APPENDIX 2.5

FURTHER INFORMATION

2530
DATA CENTRE

Design Statement – Response to Further Information Request (FI 25/60344, Section 13)

Submitted proposal

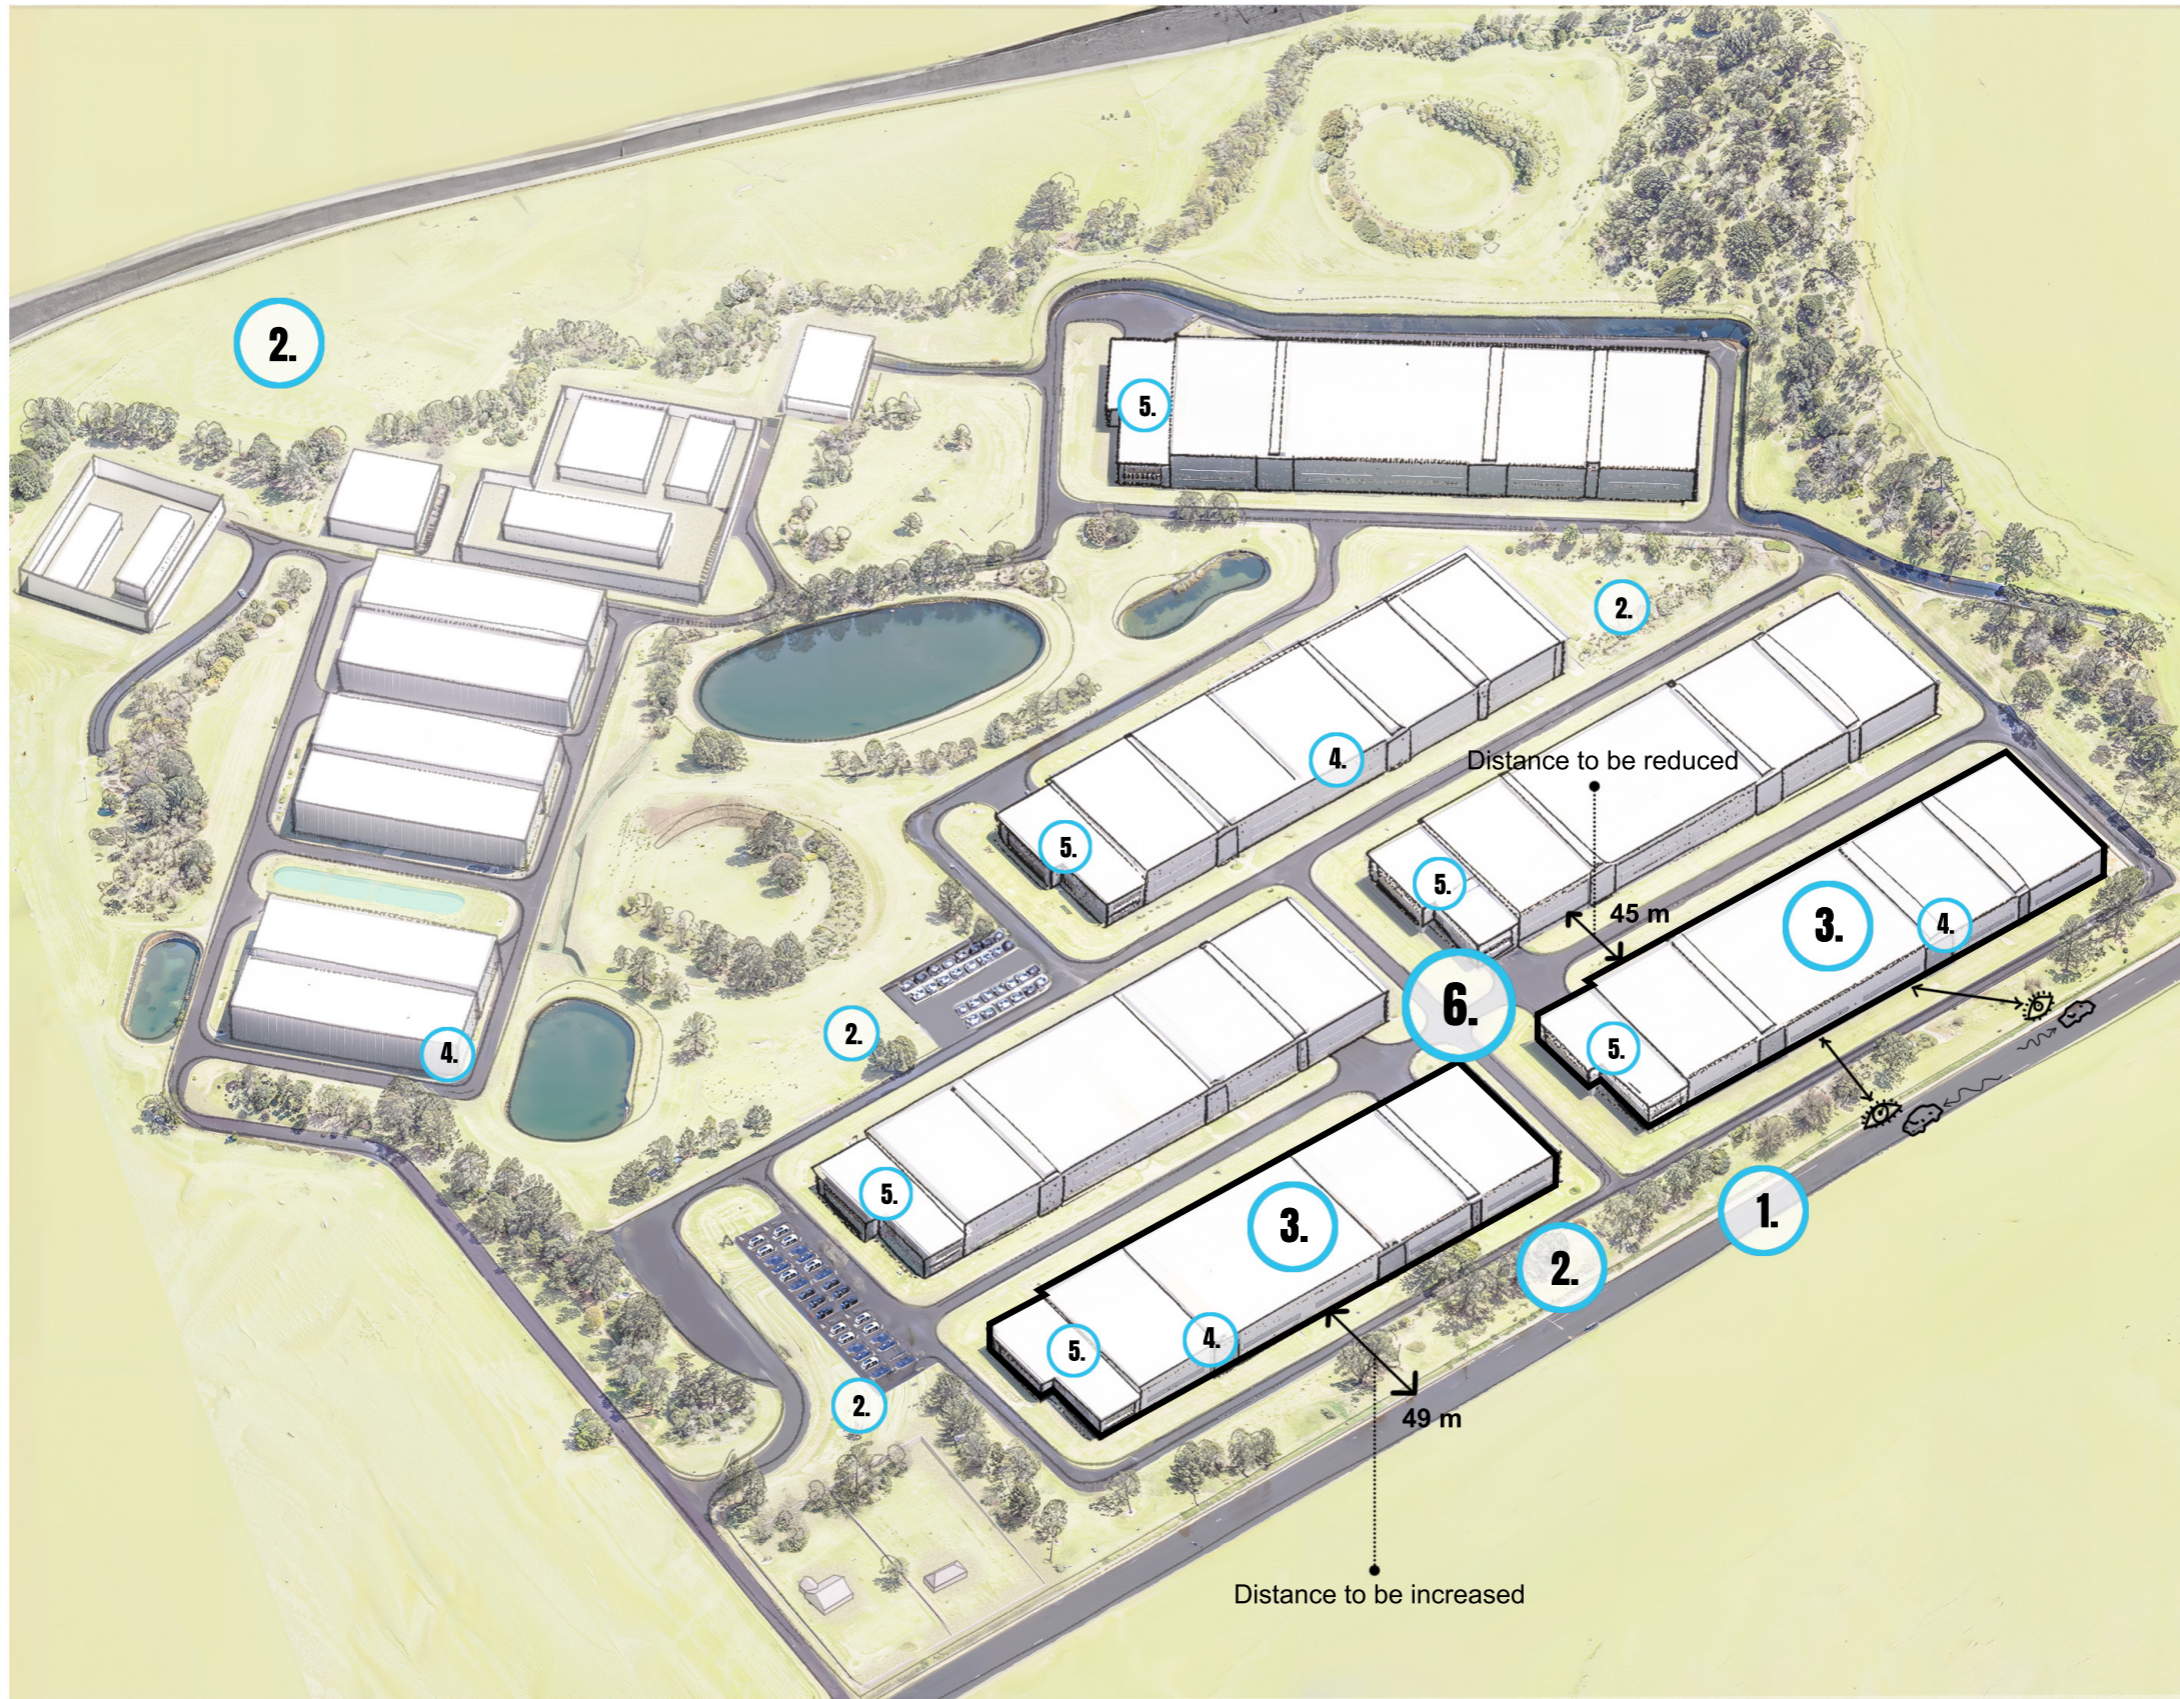
1. DISTANCE FROM THE ROAD

Buildings to be pushed back

2. PLANTING AND VEGETATION

Wider landscape buffer/screening to be provided

3. MASSING

Massing perception to be reduced by lower parapets

4. SCREENING

New architectural language facing the road

5. OFFICES

To enhance and provide a more attractive architecture for the campus

Proposed amendments

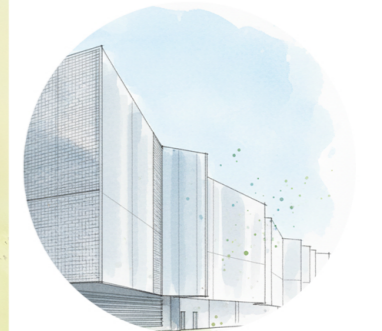
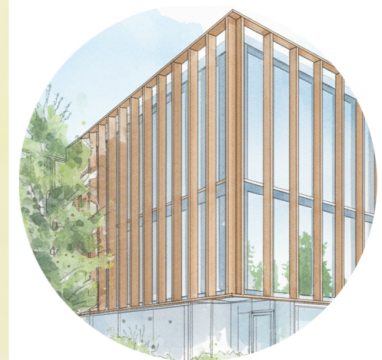
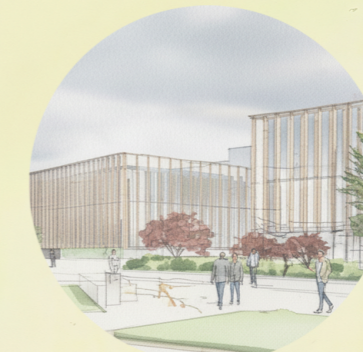
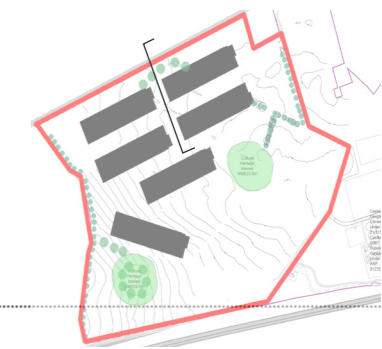
The distance between the buildings and setback from the road has been revised to create a wider gap that reduces the visual impact

A more intensive landscape is introduced. The new landscape will feature seasonal local species and grass mounds that help soften the impact on the surrounding context

The car parking spaces will be relocated to create new mitigation spaces

Several actions will be taken to reduce the perceived massing, such as pulling the parapet back from the building edge, reducing the actual height by 2 meters

A metal veil will be applied to the buildings to soften their overall massing and scale on the primary R446 elevation and other prominent elevations visible along key internal routes.

The buildings will receive enhanced architectural treatment to the office elements, providing a stronger sense of identity and place

Bringing the offices closer together aims to create a campus-like environment. This layout can foster a sense of identity for the place reinforced by hard-landscaped areas

Comparison section diagram

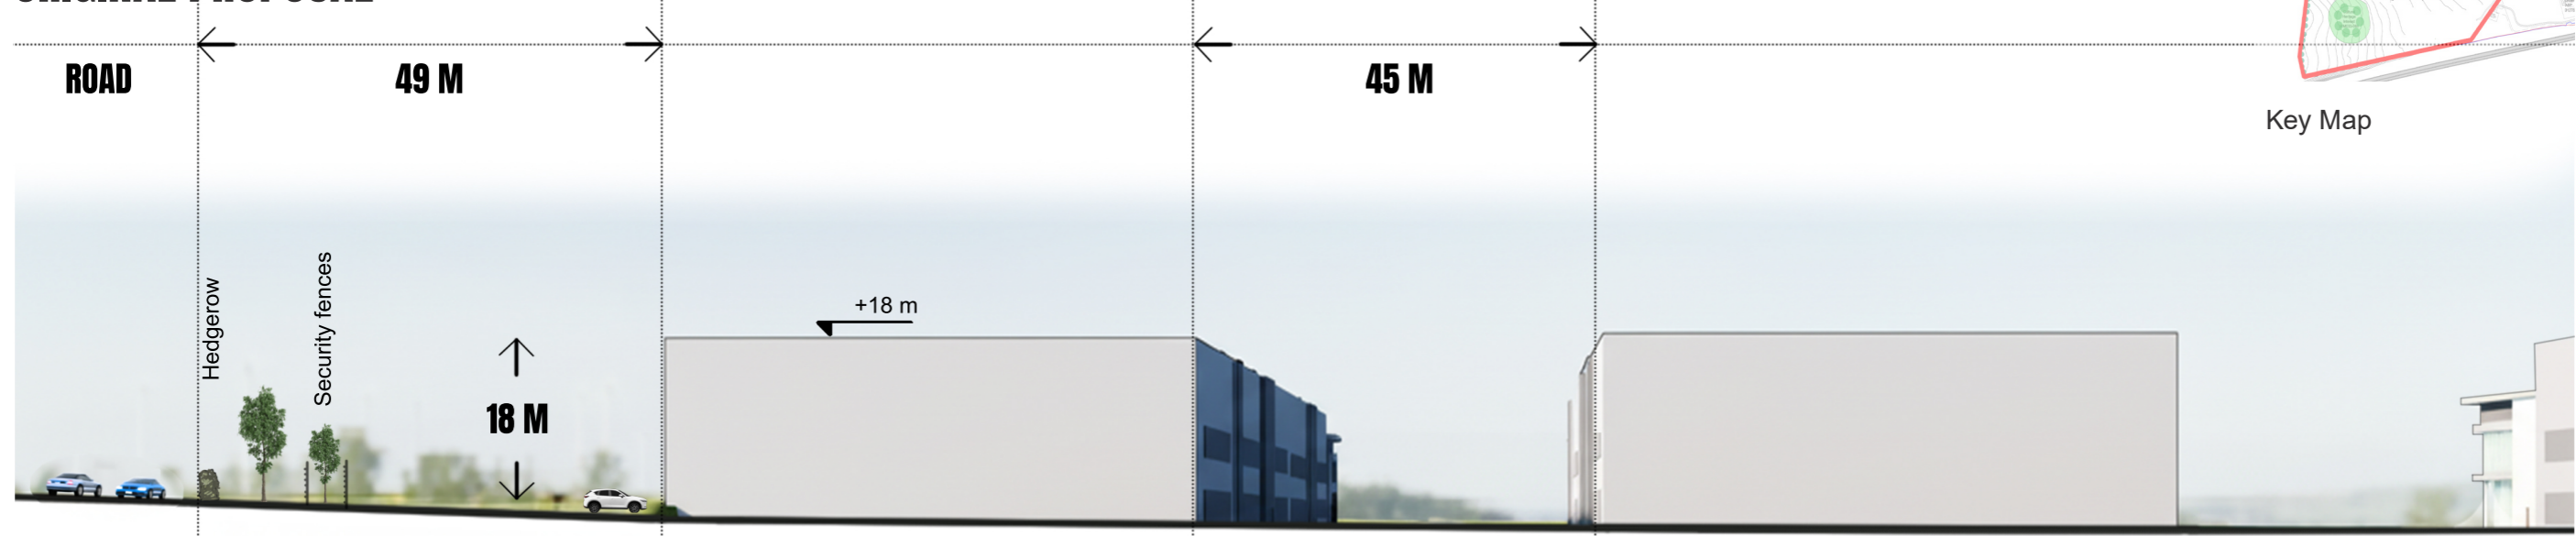
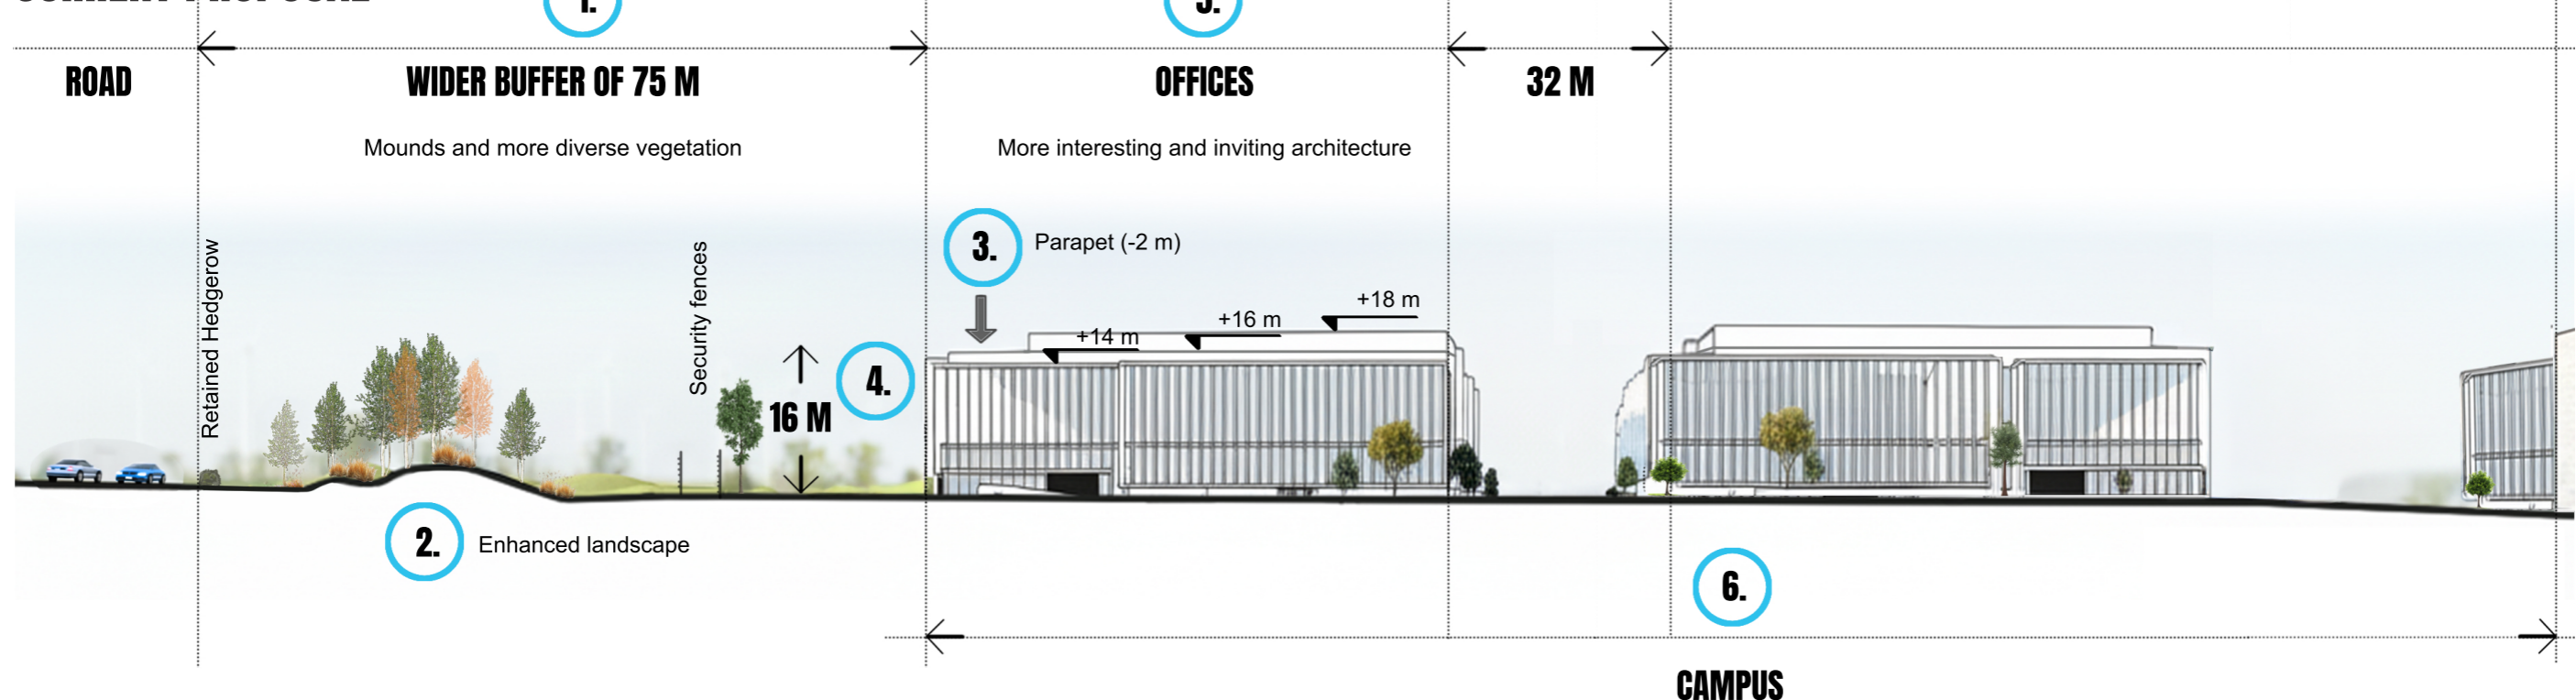
Position of the offices changes to the center of the scheme

Design evolution

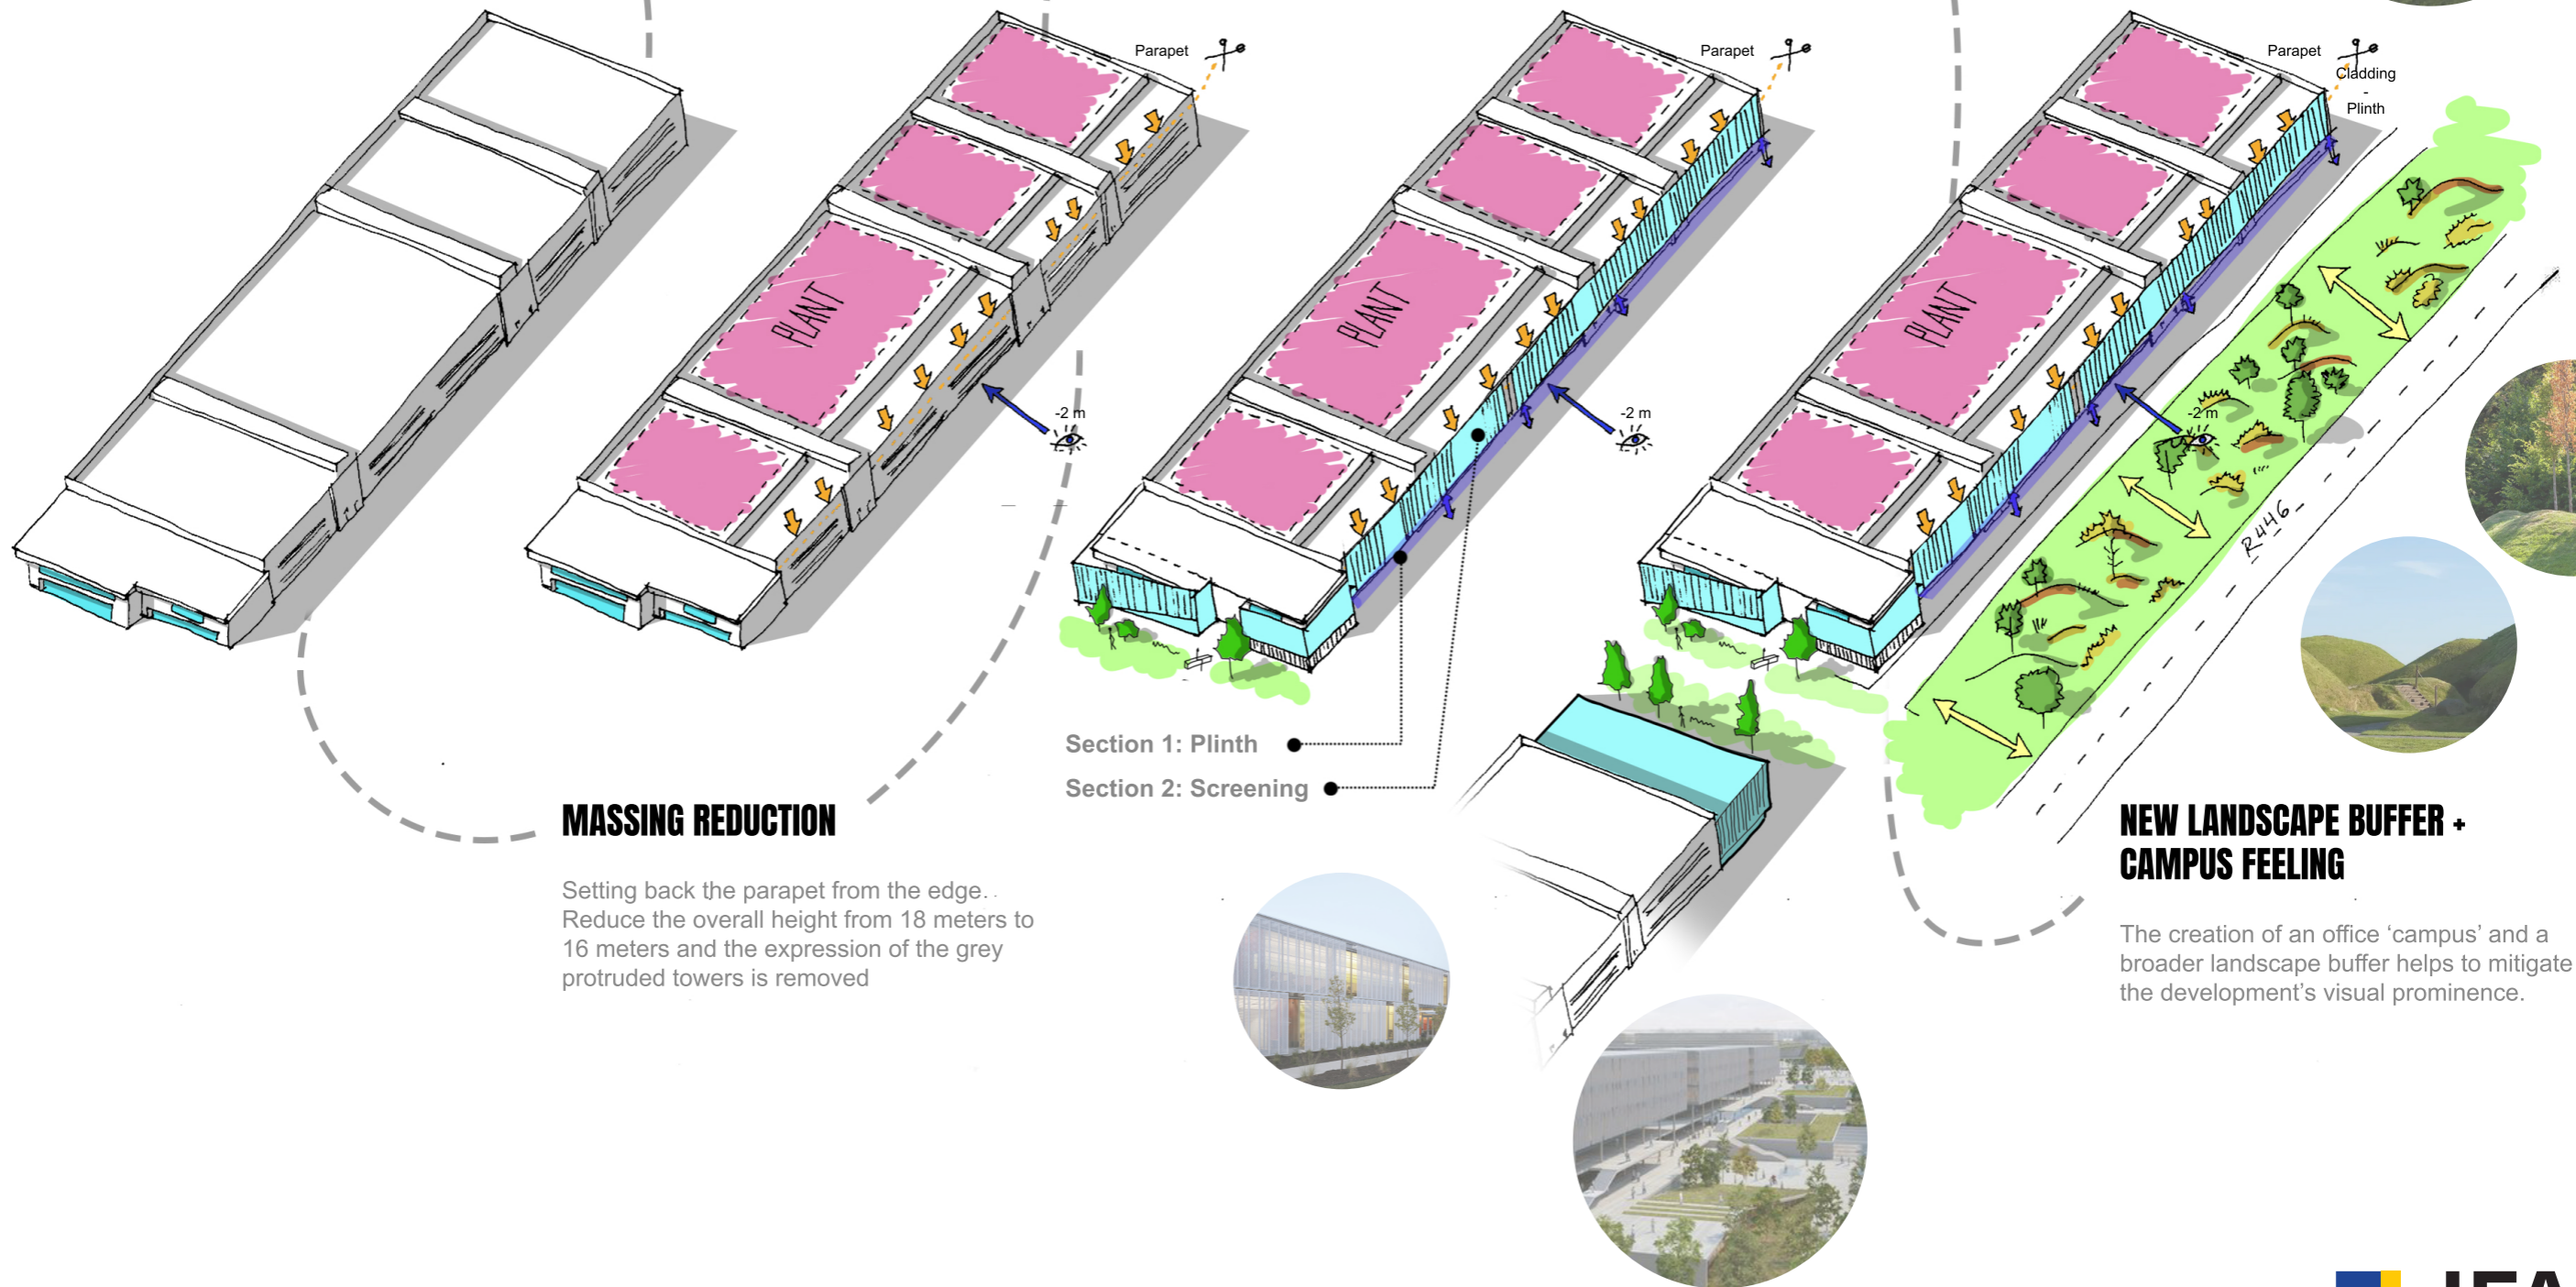
The submitted building reflects an industrial-shed typology, defined by a grey-toned color palette, ventilation openings and vertical stair cores volumes. The office area continues this material language

A screening is included wrapping around the building to provide a new attractive expression.

Setting back the parapet from the edge. . Reduce the overall height from 18 meters to 16 meters and the expression of the grey protruded towers is removed

The creation of an office 'campus' and a broader landscape buffer helps to mitigate the development's visual prominence.
